**From:** Jerry Hintze  
**To:** Dennis Killian; George Cross  
**Date:** 3/22/2007 2:53 PM  
**Subject:** Bob Allen - Siemens

# History of IPSC Experience with ABT Burners

Presentation for Siemens, March 15, 2007

Reference: Contract 04-45606 -Unit 2 Low NOx Burners

Burner Barrel Erosion, F5 Burner

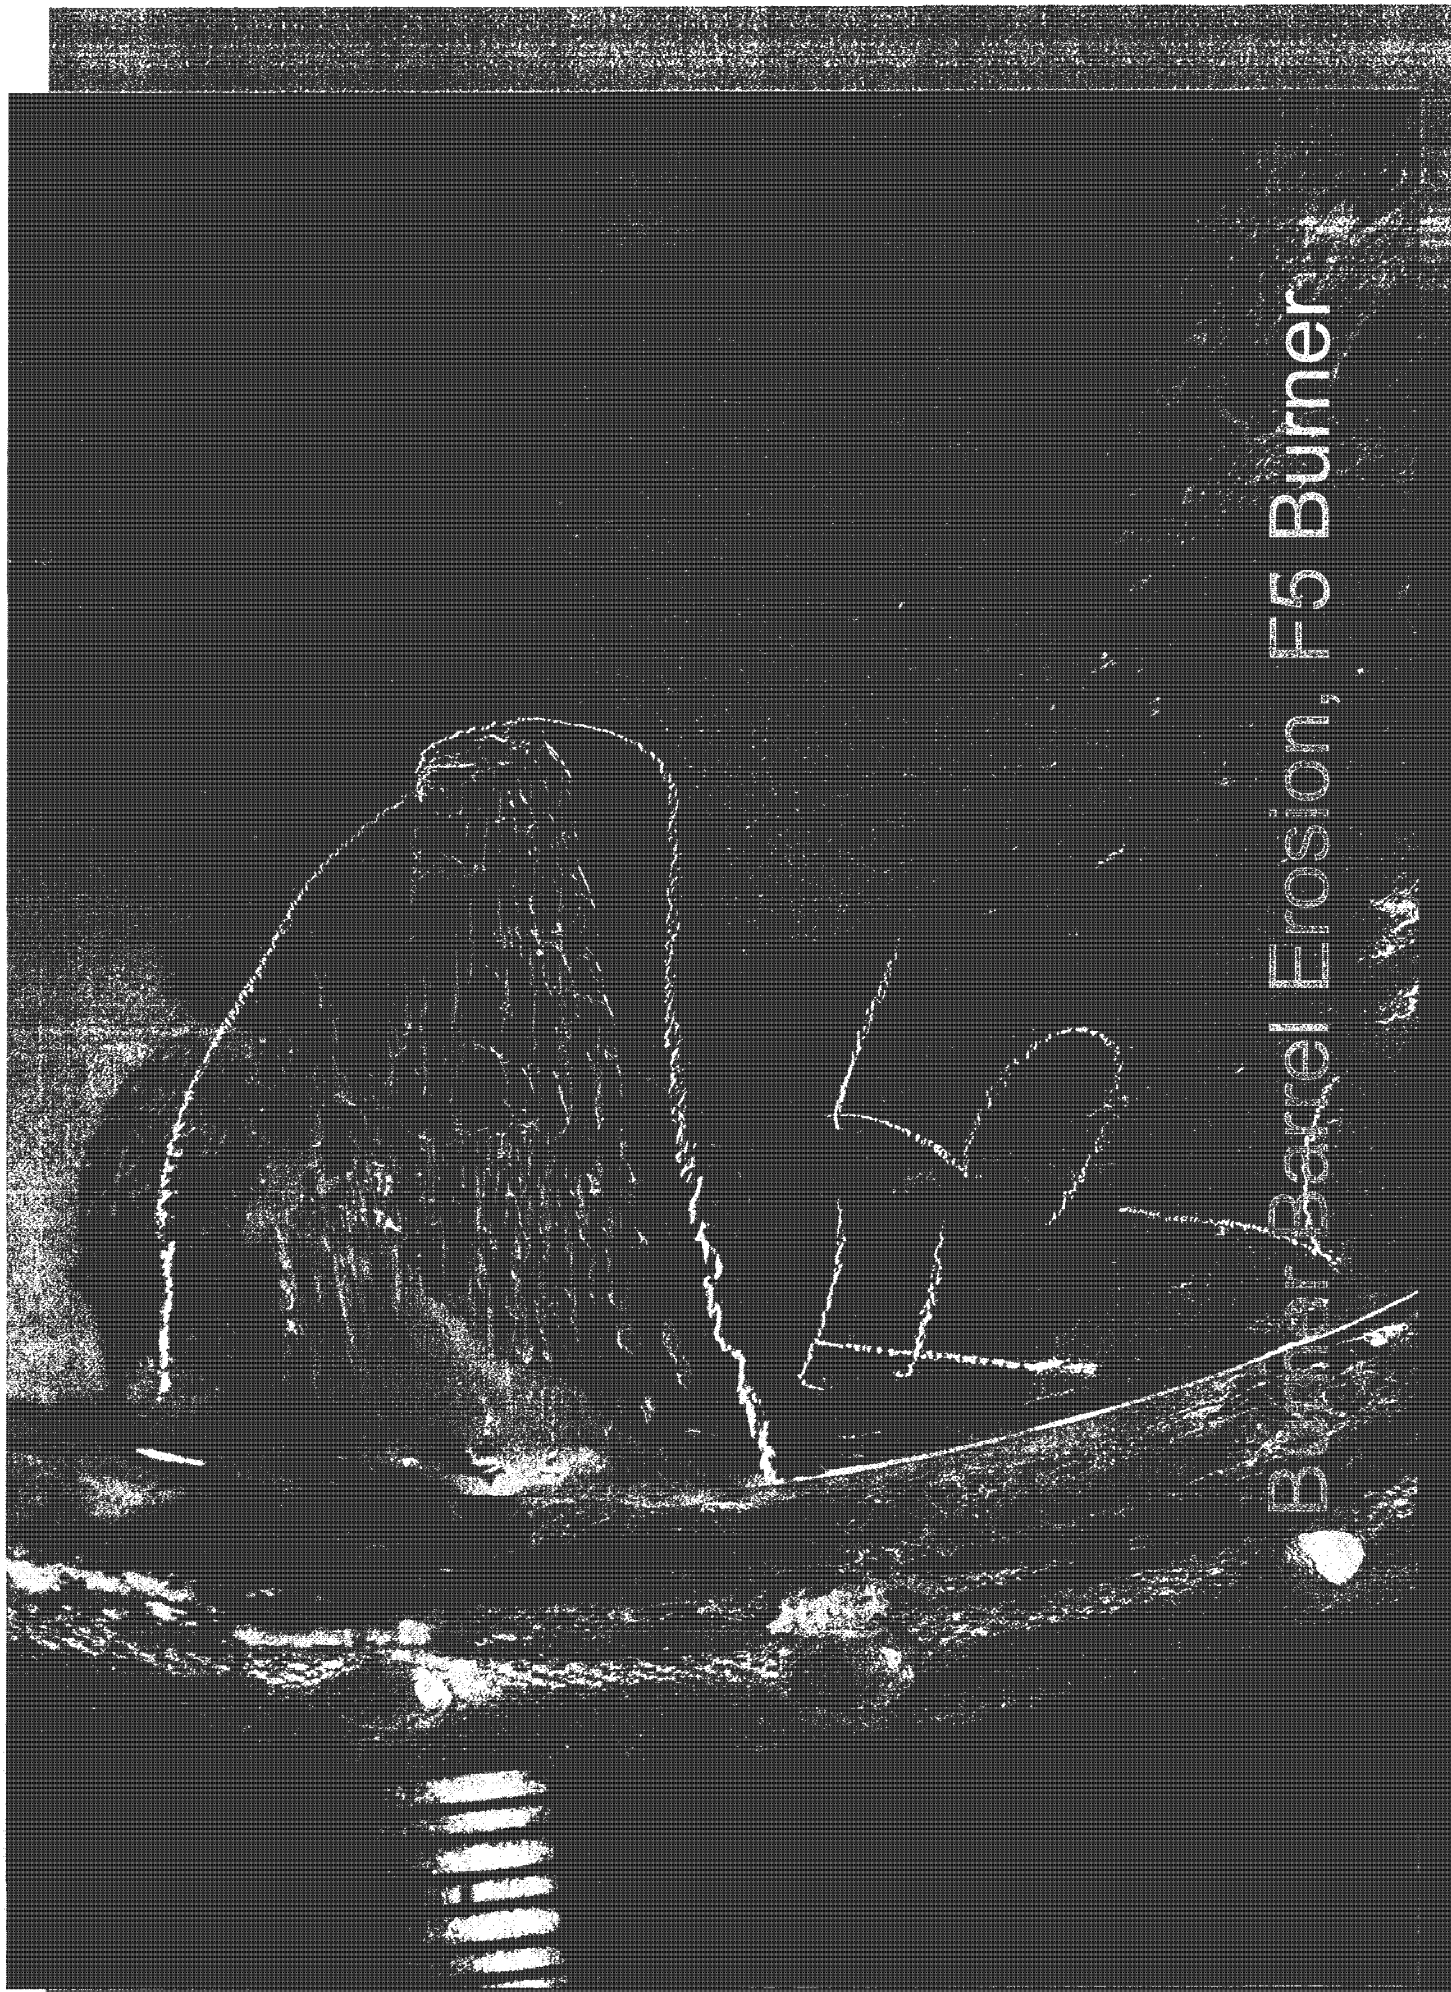
- All 48 fuel injectors were pulled and inspected
- 20 of the tips were irreparable and replaced with straight tips. 28 had tip liners installed.
- 7 burners with holes in the injector barrel on the horizontal plane. Many more very thin. All had erosion in this area.
- Diffuser and wear liner installed on all 48 burners

# April 2006 Outage

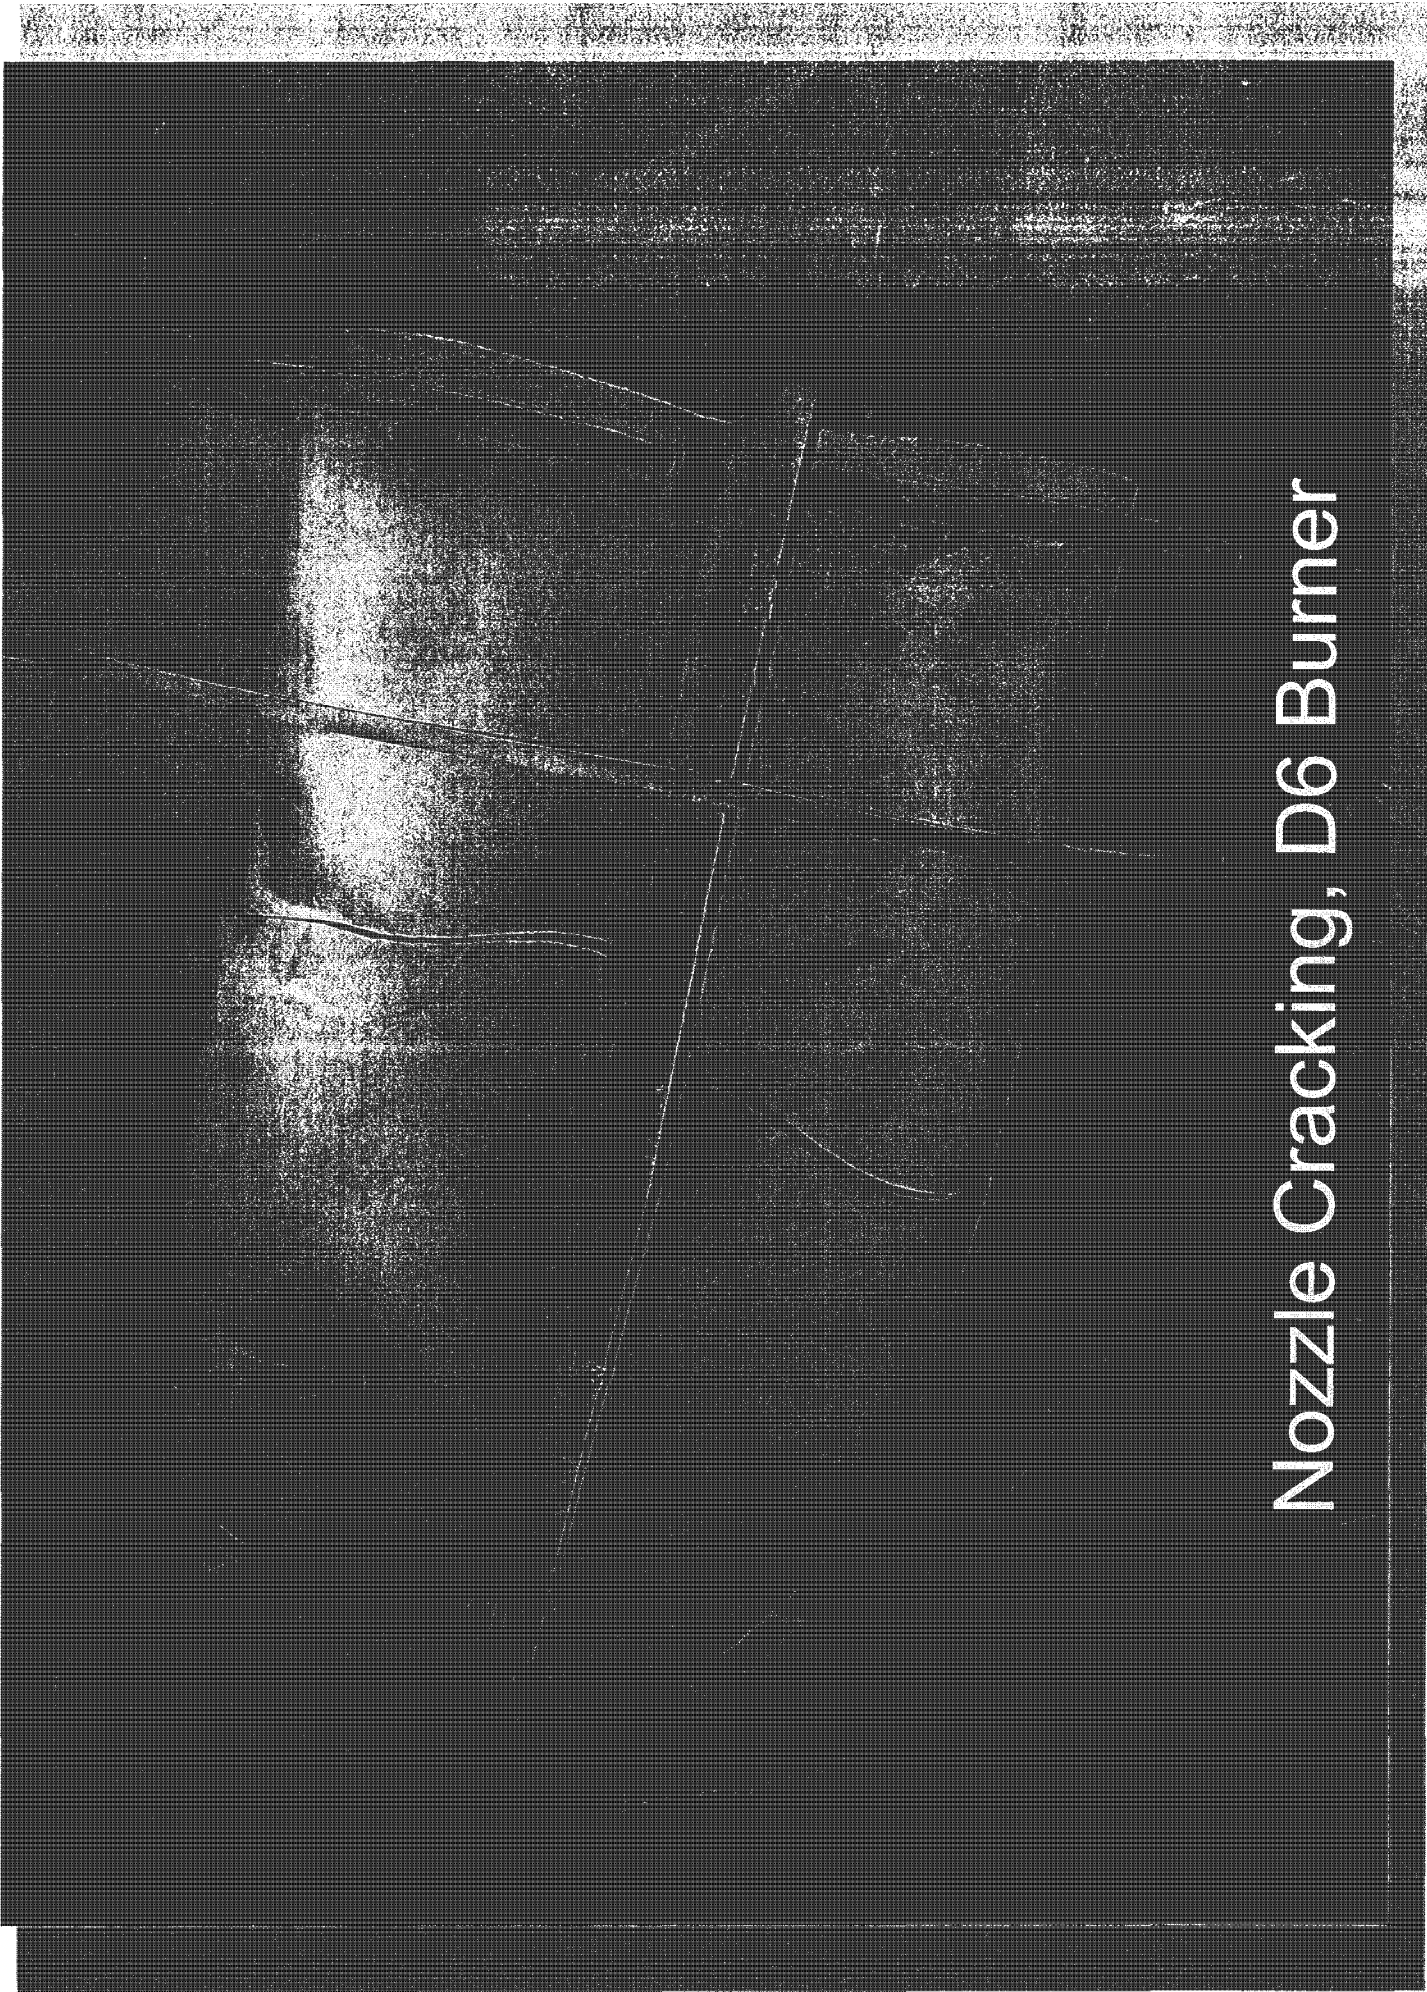
- All 48 fuel injectors were pulled and inspected
- 20 of the tips were irreparable and replaced with straight tips. 28 had tip liners installed
- 7 burners with holes in the injector barrel on the horizontal plane. Many more very thin. All had erosion in this area.
- Diffuser and wear liner installed on all 48 burners

# Nozzle Cracking, D6 Burner

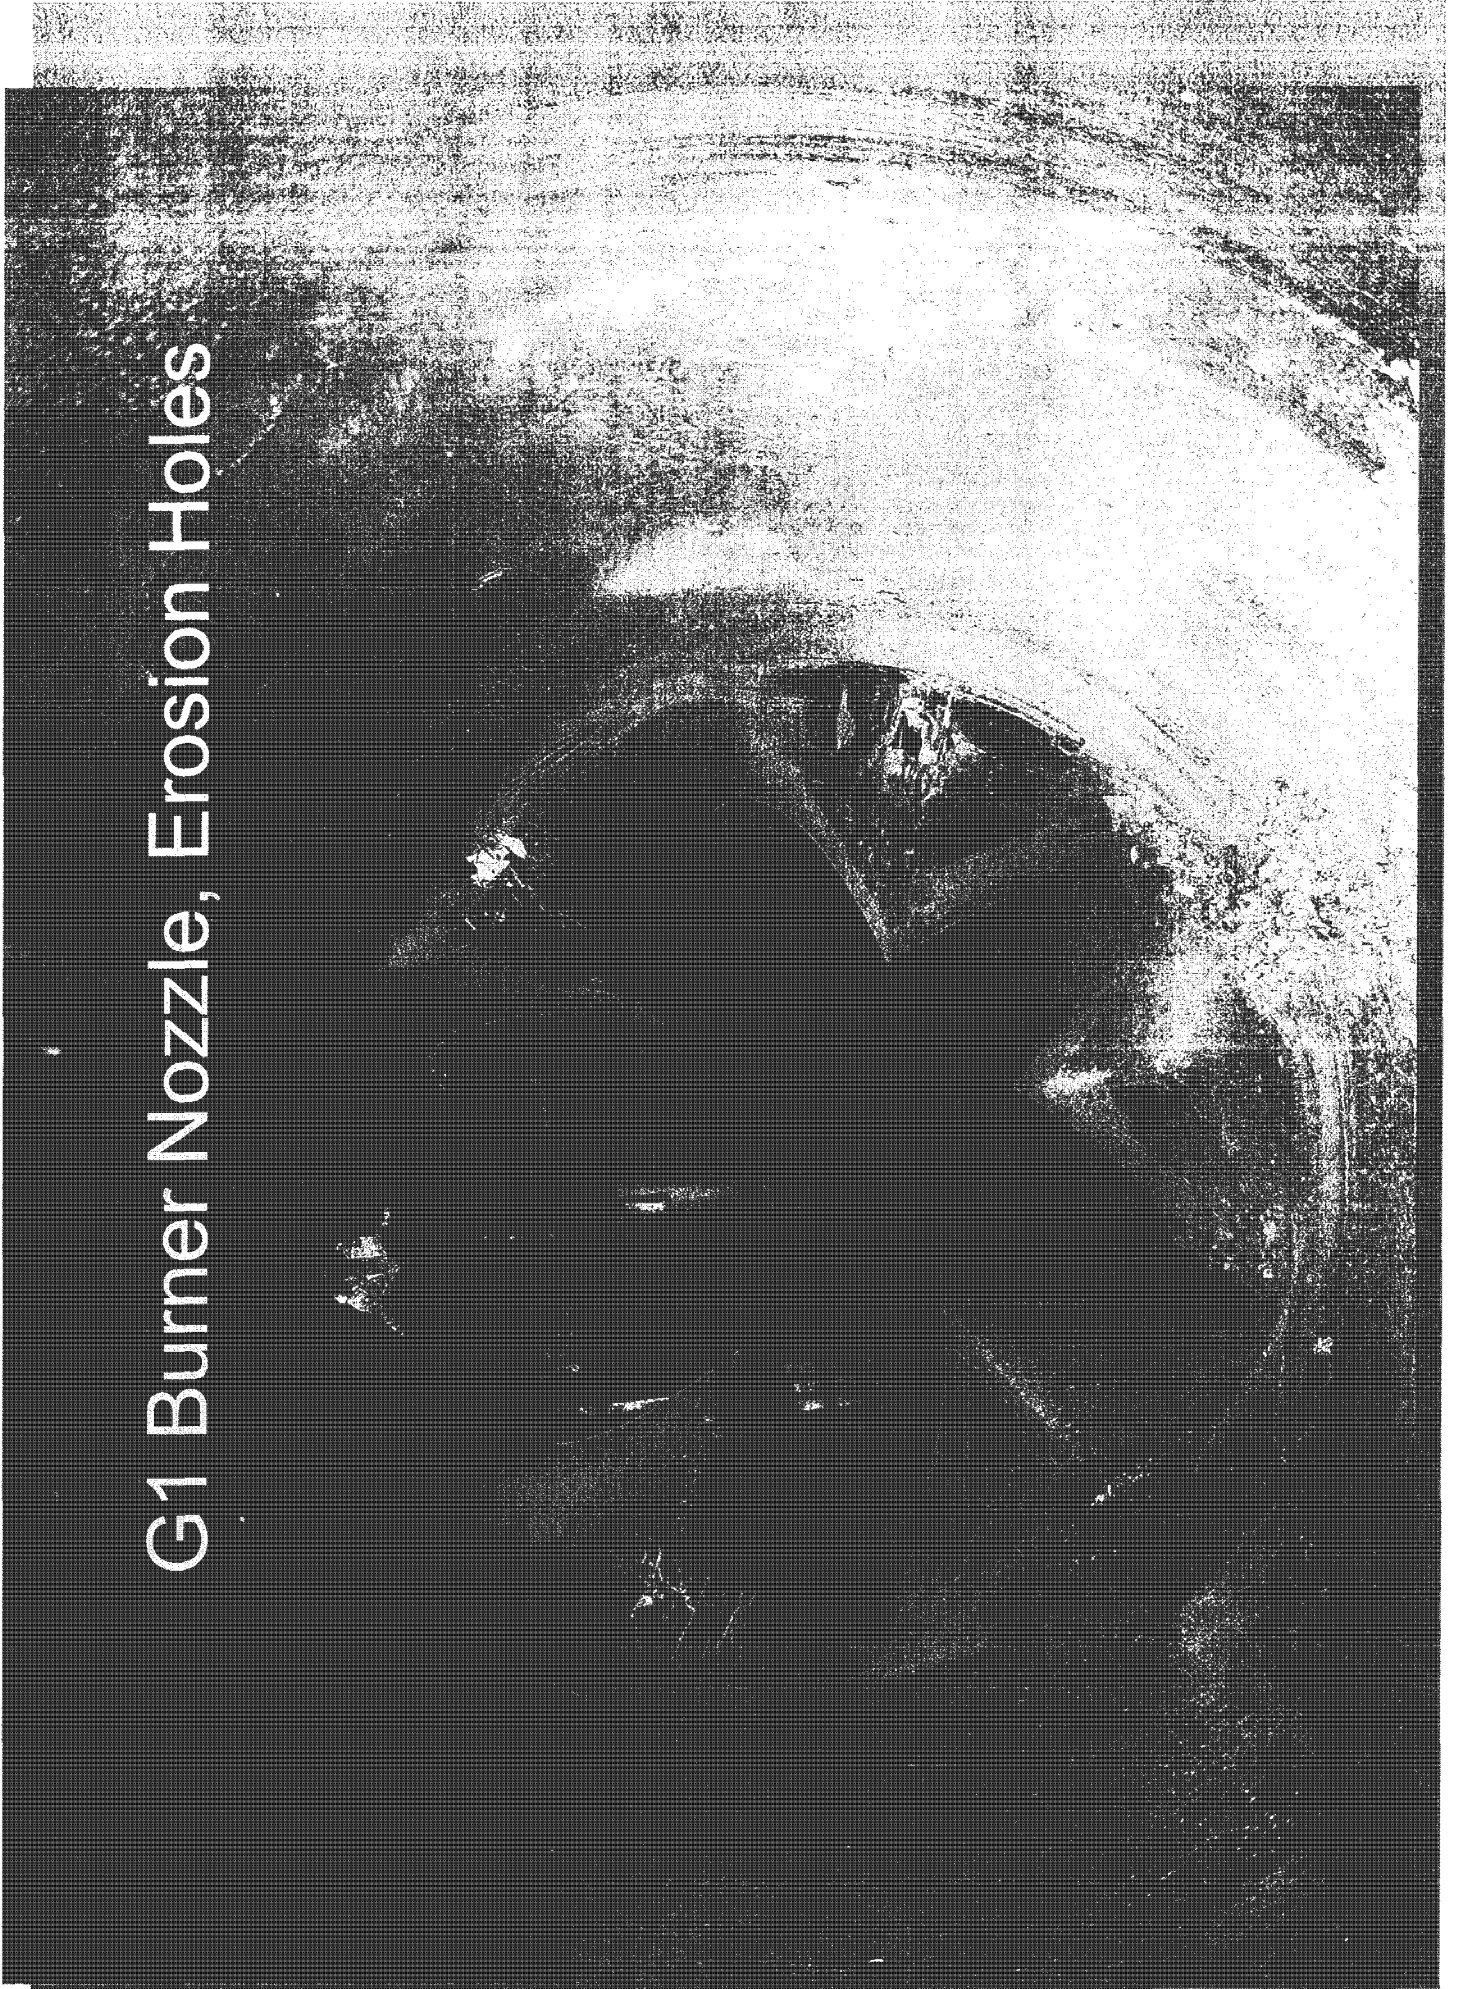
- Nozzles cracked from thermal stresses inherent in their design.
- ABT claimed that no cooling air was required, IPSC always had cooling air on all out of service burner rows.

- All cracking originated from the dissimilar metal weld in the barrel. IPSC did not inform them of previous problems with B&W burner welds.
